Department of Planning + Urban Design

To: Board of Zoning Appeals
From: Planning and Urban Design Staff
Date: March 13, 2023
Re: Appeal BOZA2022-076

Purpose:
This appeal has been filed to grant a variance from the requirement to screen mechanical equipment on a roof. Section 27-699(b)(6) states that mechanical equipment or other utility hardware on a building shall be screened from public view. Rooftop mechanical equipment will be up to nine (9) feet, three (3) inches above the edge of the rooftop. The appellant is requesting rooftop screening of zero (0) feet, a violation of nine (9) feet, three (3) inches.

Property Location: 6220 Kansas Avenue
Kansas City, Kansas 66111

A10 ROOF PLAN
3/32" = 1'-0"

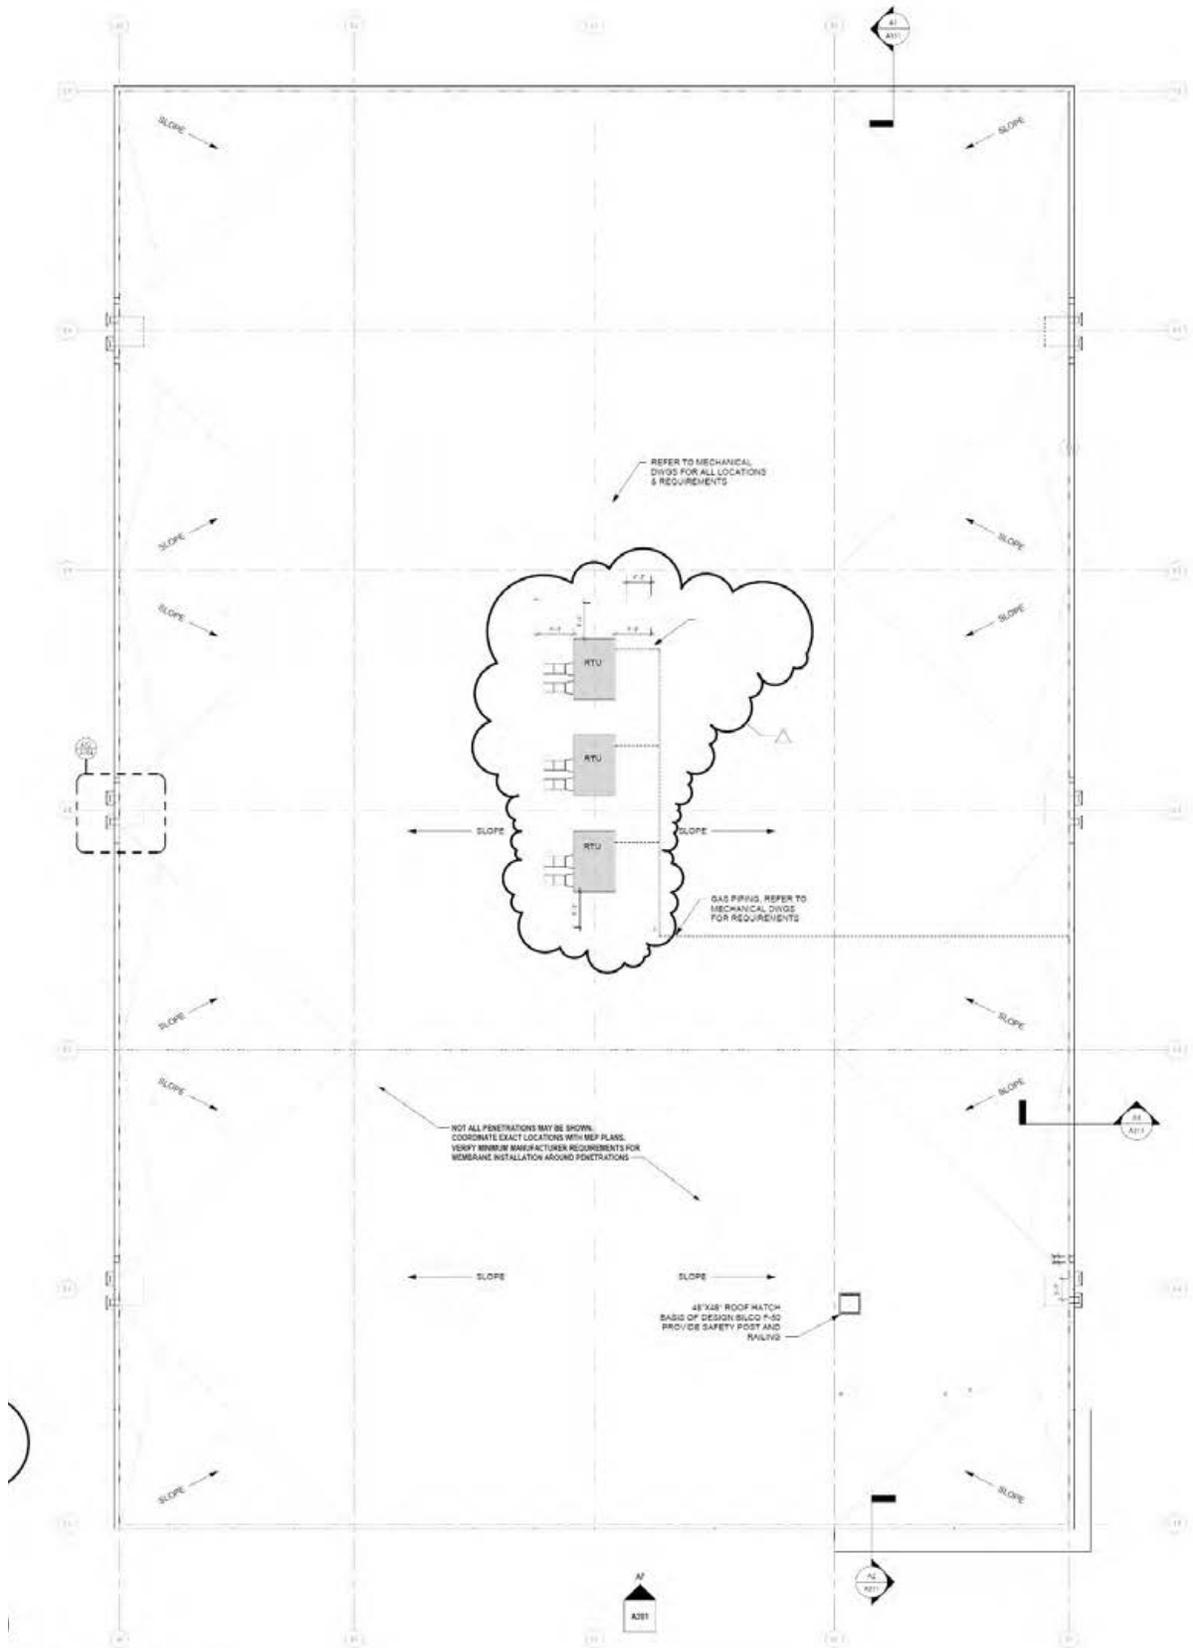
1. What is the load rating for the roof, i.e. how much weight can the roof hold?

2. In lieu of applying for a variance from the rooftop mechanical screening requirement, would Applicant consider increasing the height of the existing edge parapet in order to serve as the effective screening for said rooftop equipment?

Applicant Response: Roof live load capacity as listed on the drawings, is 20 psf.

Applicant Response: Concrete walls would only be allowed to be raised 2 feet without completely redoing the structural design of panels and footings. Adding 2 feet would still require a variance.
